Requesting Organization: Department of Environment and Conservation

Information Request No.: DEC, Wildlife Division – 2

Reference: Caribou and Their Predators Component Study; Volume 2B, Section 12.3 Caribou

Information Requested: Incorporate temporal aspects of Labrador caribou distribution into the environmental assessment.

FIGURE WD 2-1

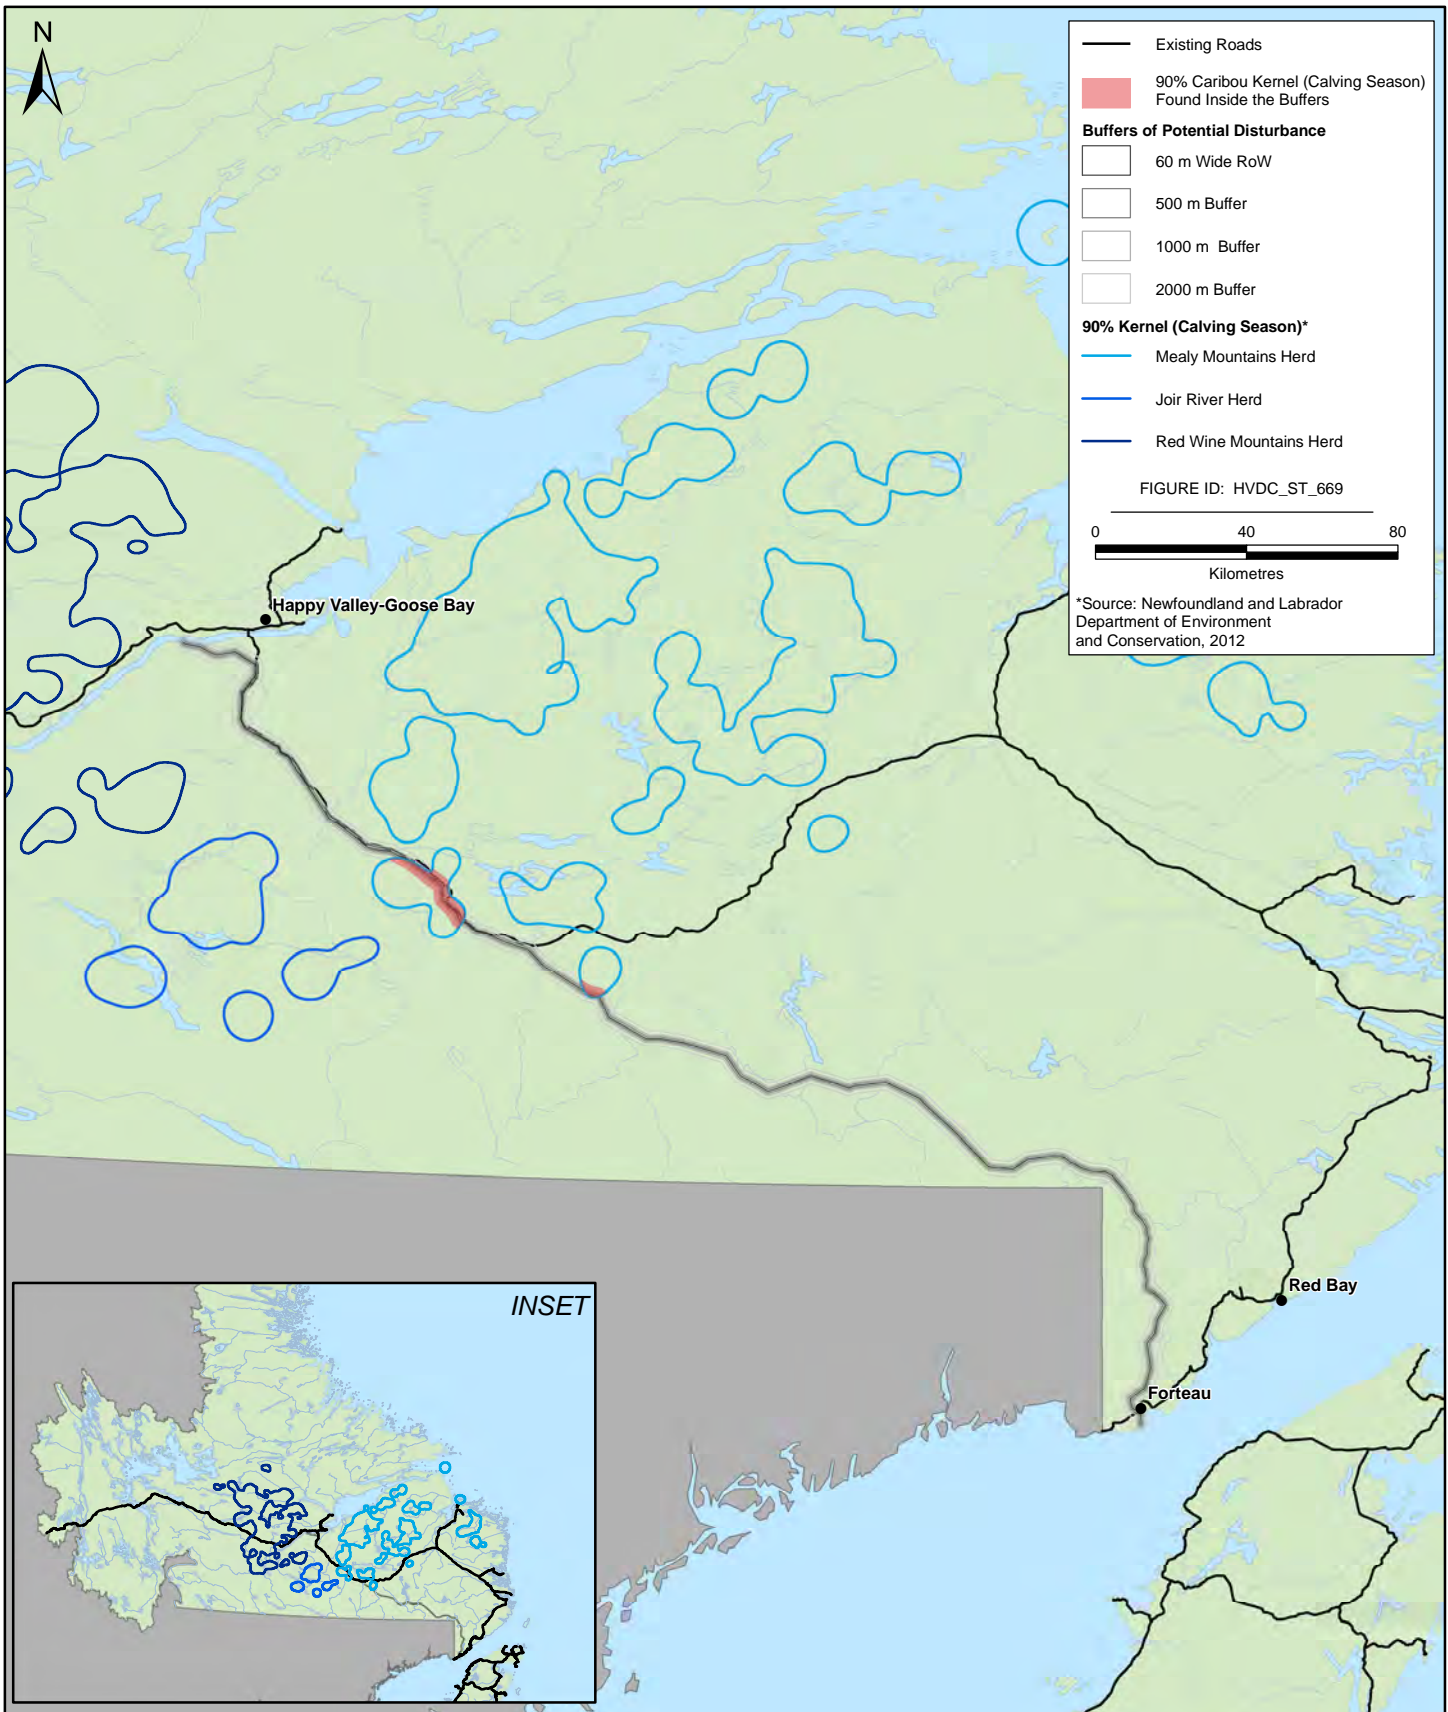
Using 90% kernel shape files of caribou telemetry data from 2007-2012 for Labrador caribou herds provided by Wildlife Division. These files are organized for wintering and calving/post-calving periods. Using the current (15 October 2012) ROW routing, Nalcor proposes to:

- Present results with respect to seasonal range loss and at the scale of the population range;
 - Create a separate figure showing the 90% kernel for each season for each herd and the overlap with the current routing (i.e., at least four figures); and

There is no overlap of the 60 m wide right-of-way or any of the three assessment areas examined (i.e., 500 m, 1,000 m or 2,000 m buffer widths) with the 90% probability of occupancy kernel for the calving season (Figure WD2-1) or the winter season (Figure WD2-2) for the Red Wine Mountains Herd or the Joir River (Table 1).

There is no overlap of the 60 m wide right-of-way with either 500 m or 1,000 m buffers and the 90% probability of occupancy kernel for the Mealy Mountains Herd in winter. However, there is overlap with the 2,000 m buffer and the 90% kernel in winter (0.01%), which occurs on the south-west edge of the 90% probability of occupancy kernel (Table 1; Figure WD2-2). There is also overlap with the Mealy Mountains Herd 90% kernel, the right-of-way (0.02%) and the right-of-way with 500 m (0.33%), 1,000 m (0.62%) and 2,000 m (1.19%) buffers in summer (Figure WD2-1).

FIGURE WD 3-1

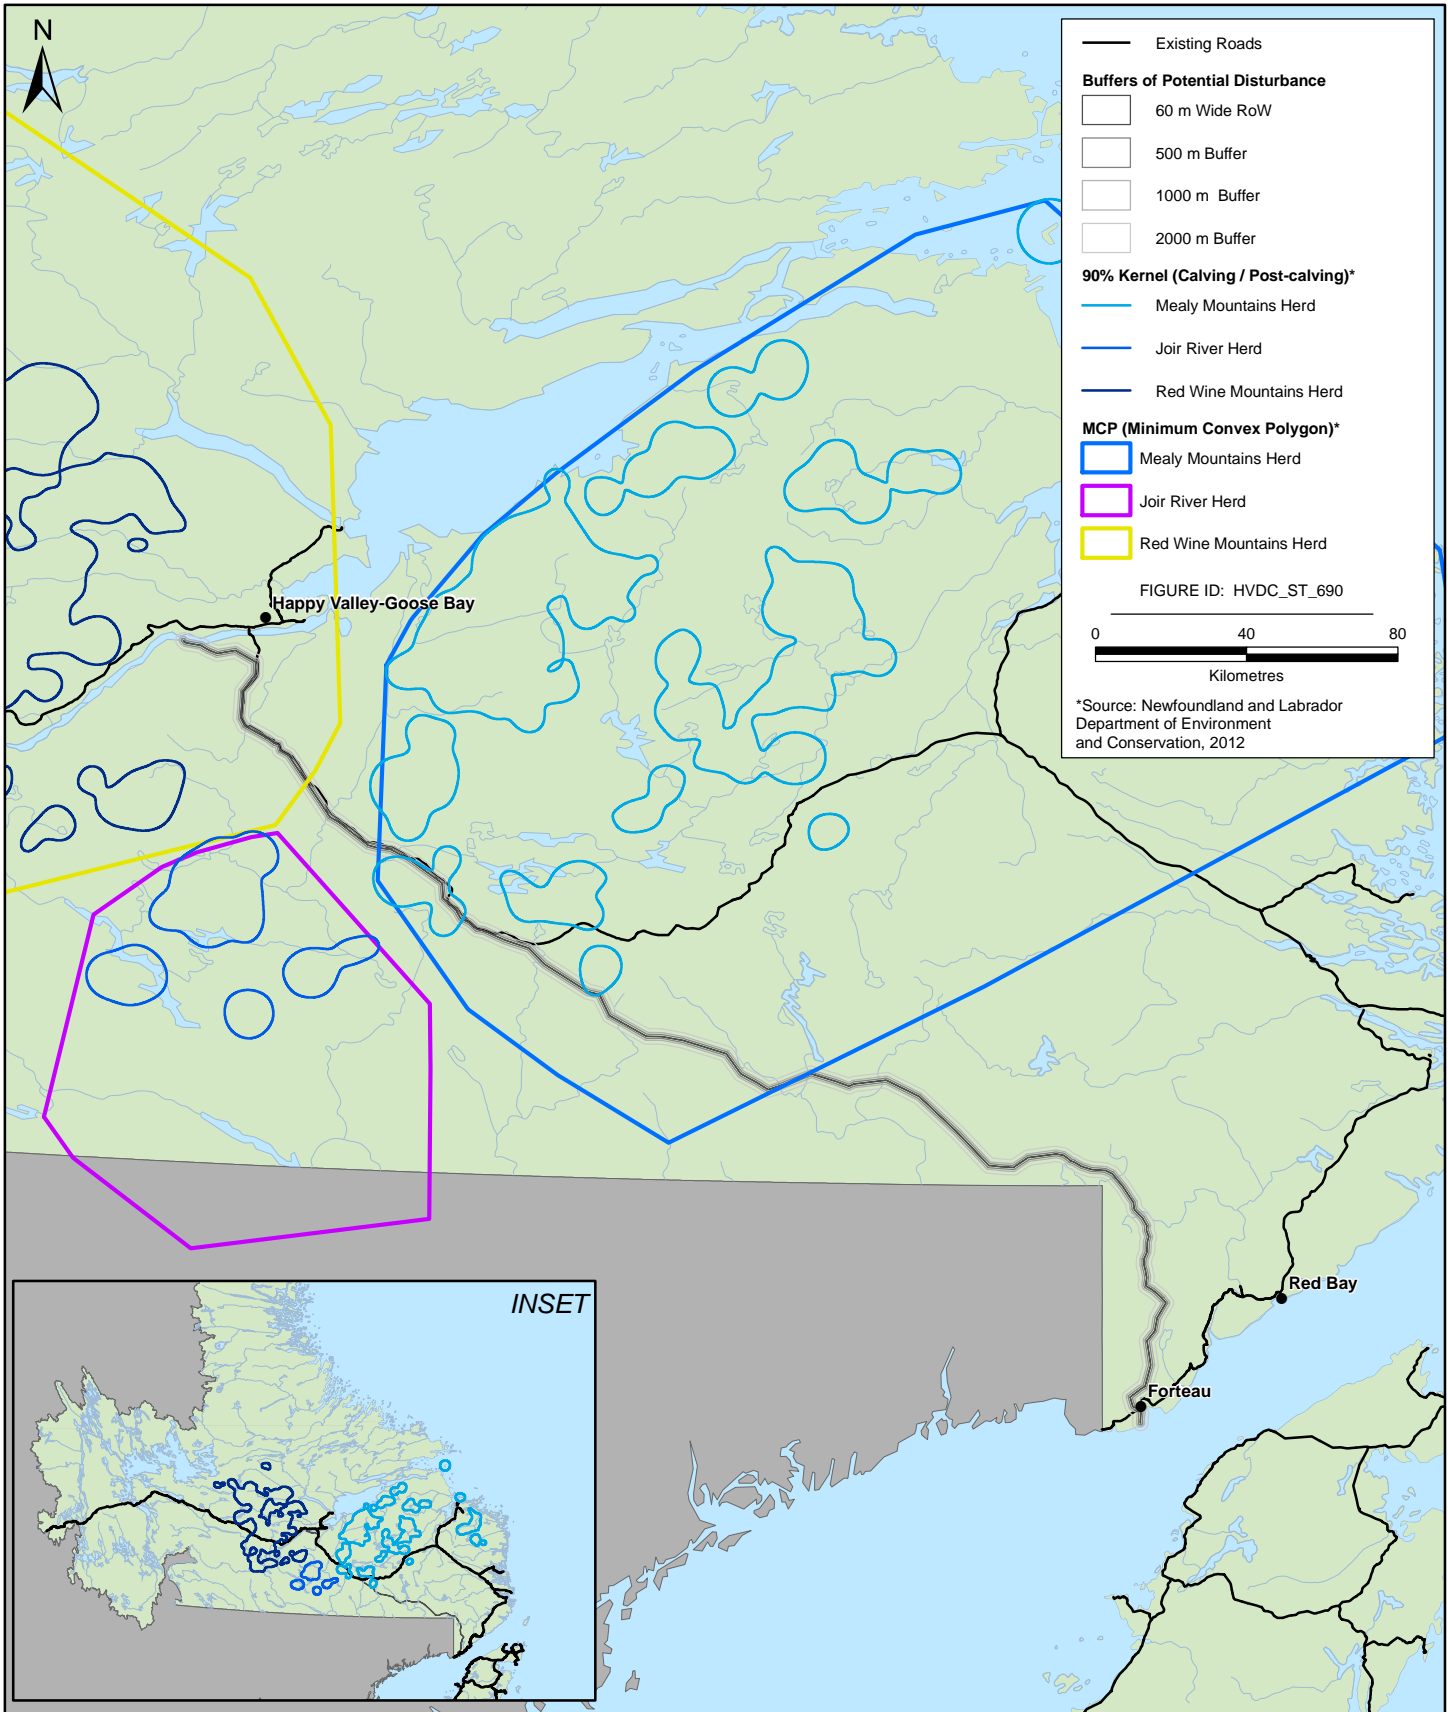
Information Requested: Evaluate potential avoidance of the actual ROW by caribou

- Calculate the amount of potential indirect habitat loss due to avoidance of sensory disturbance within the 1.06 km wide assessment area by overlaying the recently updated MCPs of relevant Labrador caribou herds on the current 60 m wide ROW and associated 500 m wide buffer on each side to quantify the area and percentage of each herd range potentially affected. This will include an examination of data gaps in winter range use east of the Kenamu River;

The potential clearing associated with the Project overlaps the ranges of the Red Wine Mountains (RWM) and Mealy Mountains (MM) Caribou Herds (Figures WD3-1 and WD3-2). The MCP calculated for the Joir River (JR) Herd does not overlap the Project, although the Wildlife Division considers this ‘subpopulation’ to be associated with the MM Herd. This potential clearing for the right-of-way overlaps the 90% kernels only in the case of the calving / post-calving kernel for the MM Herd and does not affect the RWM herd range. Clearing for the Project will not occur within the 90% occupancy kernel of the RWM range because, in response to concerns raised by regulators and Aboriginal groups regarding caribou, Nalcor has proposed to re-route the HVdc transmission line along the existing access road to the proposed Muskrat Falls generating facility. This action is not based on new information or analyses, but has been proposed as a precautionary approach to avoid the creation of additional disturbance and associated access through a portion of the RWM caribou range.

Table 1 presents the direct habitat alteration / loss that would likely occur as a result of the Project due to construction of the 60 m wide right-of-way. However, the amount of habitat directly affected will depend on the habitat type being crossed. For example, not all habitat types will require clearing of the vegetation within the right-of-way, and disturbance will be limited to the tower locations and the access trail within the right-of-way. As such, even the values presented in the following tables represent a conservative and precautionary estimate of the Project effects. The 60 m wide right-of-way will affect the 90% occupancy kernel of the MM herd only (0.02%), and only during the calving / post-calving season (Table 1).

Table 2 examines the habitat altered / lost due to indirect effects using an assessment area of a 500 m buffer around the right-of-way. This approach is consistent with Dyer et al. (2001) and the woodland caribou recovery strategy released by Environment Canada (Environment Canada 2012). This 1.06 km wide assessment area would only overlap with the calving / post-calving 90% kernel of the MM Herd (0.3%).

FIGURE WD 4-1

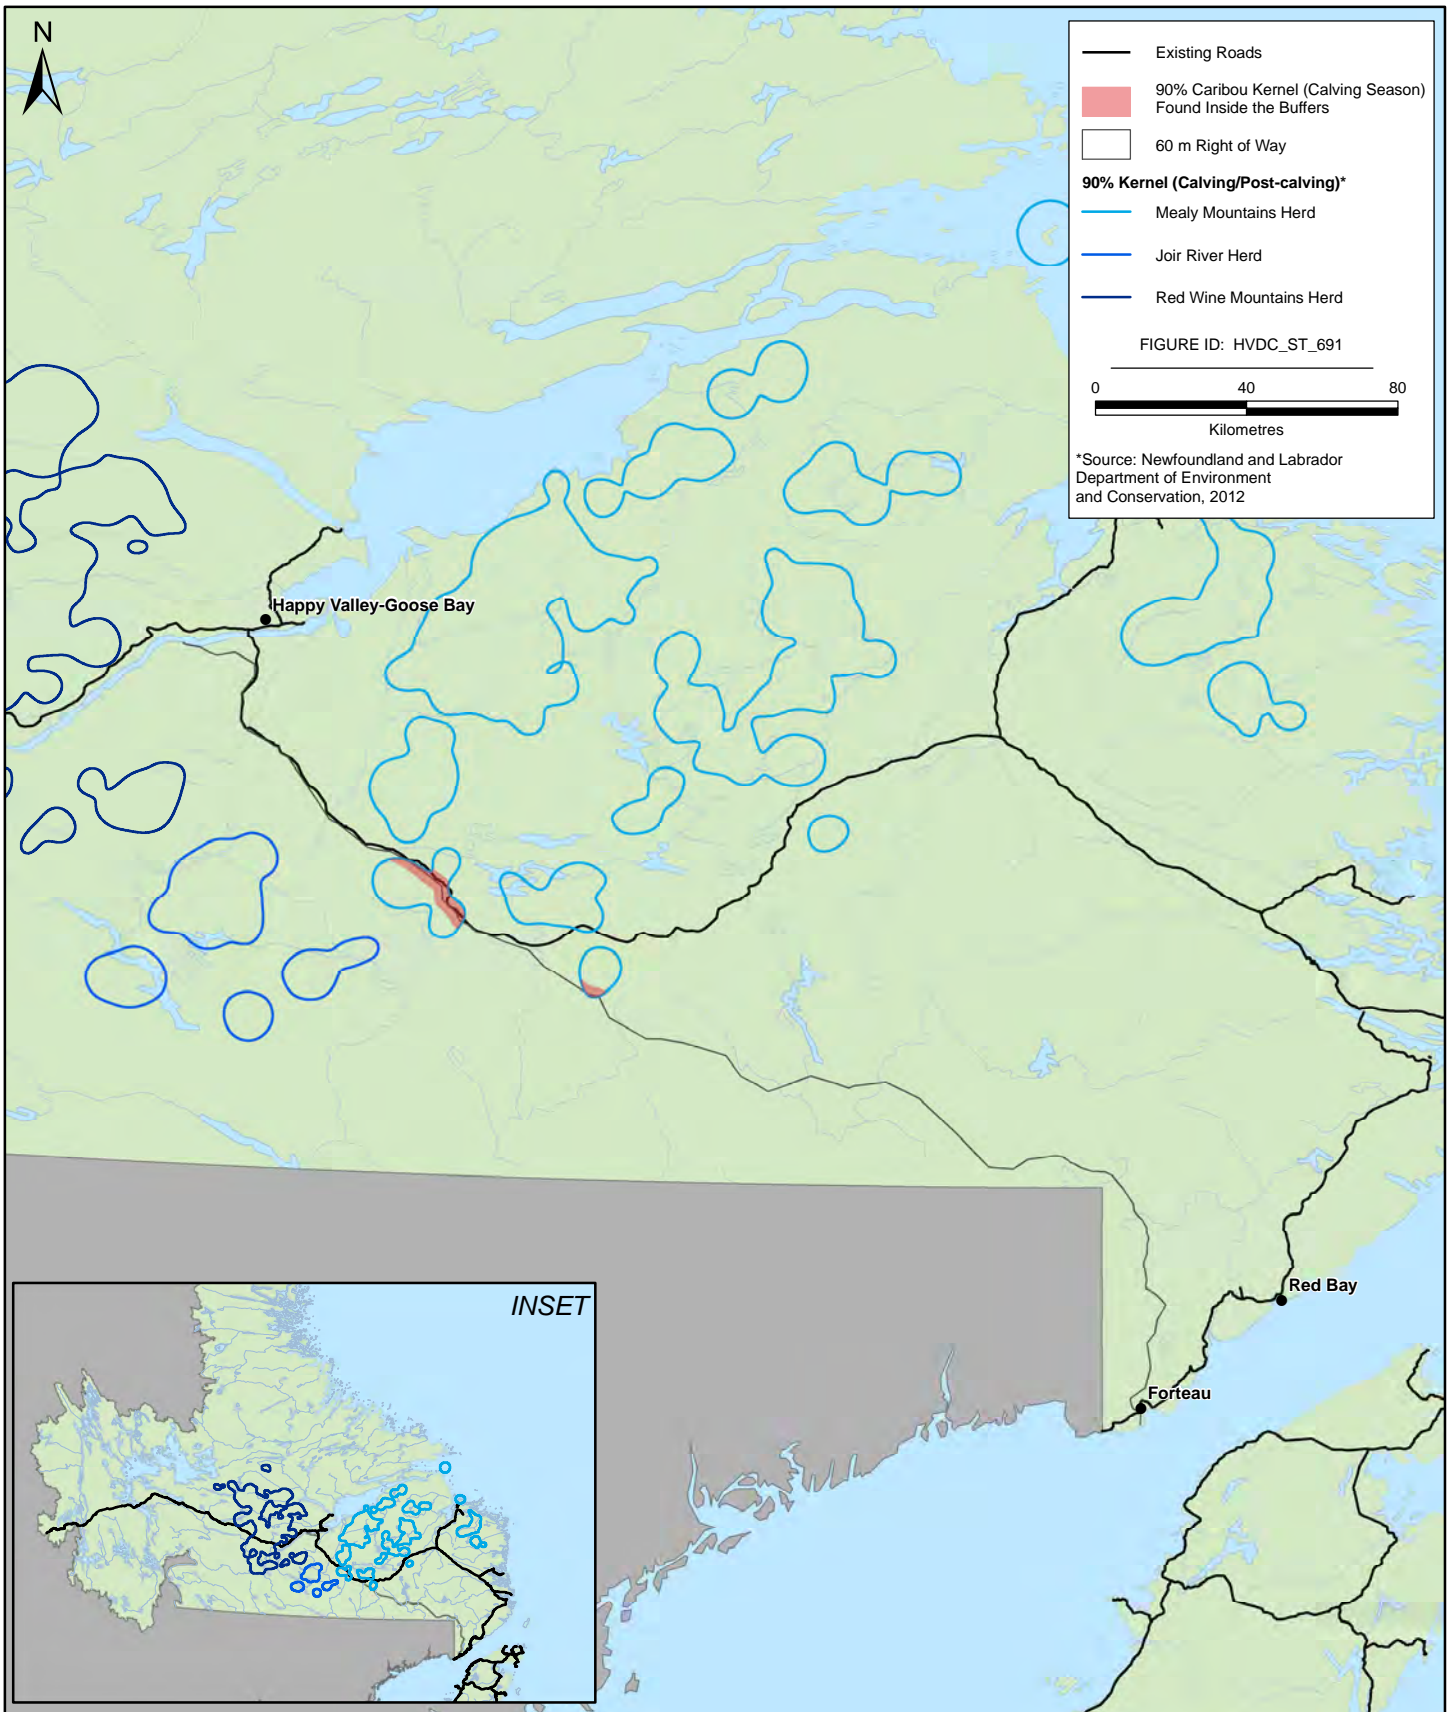
Information Requested: Range fragmentation

- Include a discussion on the effects of range fragmentation. Investigate whether the northern and southern components of the Red Wine Mountains range may become isolated from each other since the proposed transmission line will run parallel with the TLH and the river, thus potentially reducing connectivity between these portions of the range.
- Conduct a regional analysis for Labrador caribou herds to determine if there are any regional effects to caribou resulting from the project.

To further evaluate potential regional effects of the Project on Labrador caribou, Nalcor mapped the 90% probability of occupancy kernels for the caribou calving/post-calving season (Figure WD 4-1) and the winter season (Figure WD 4-2) (see the response to WD-2 and WD-3). Figure WD-4-1 and Figure WD 4-2 show that the Project right-of-way does not affect the seasonal 90% occupancy kernels for the RWM Herd or the JR Herd, and does not affect the winter 90% kernel for the MM Herd. Where the Project right-of-way lies in proximity to the winter season 90% kernels for the MM Herd, the right-of-way is on the south-west side of the TLH3 while the winter habitat use areas are to the north-east of the TLH3. The 60 m wide right-of-way does cross the calving/post-calving season 90% kernel for the MM Herd where the Project is routed along the TLH3 (i.e., an existing disturbance corridor) to avoid additional habitat fragmentation.

Based on the above information, and referring to Figure WD-4-1 and Figure WD-4-2 to provide a visual representation of the minimal overlap of the Project right-of-way with habitat during the sensitive periods of calving/post-calving and winter (see also the response to Information Request WD-2 and Information Request WD-3), regional effects (e.g., habitat fragmentation) are not likely to affect caribou populations on a regional scale (Table 12.3.7-1). The effects of the Project relative to baseline conditions are not likely to affect the viability or recovery of woodland caribou populations in Central and Southeastern Labrador and Newfoundland. Therefore, the Project is not likely to result in significant adverse environmental effects on caribou (Section 12.3.7.2, page 12-134). The information presented in this response does not affect the mitigation, findings or confidence in the conclusions of the EIS.
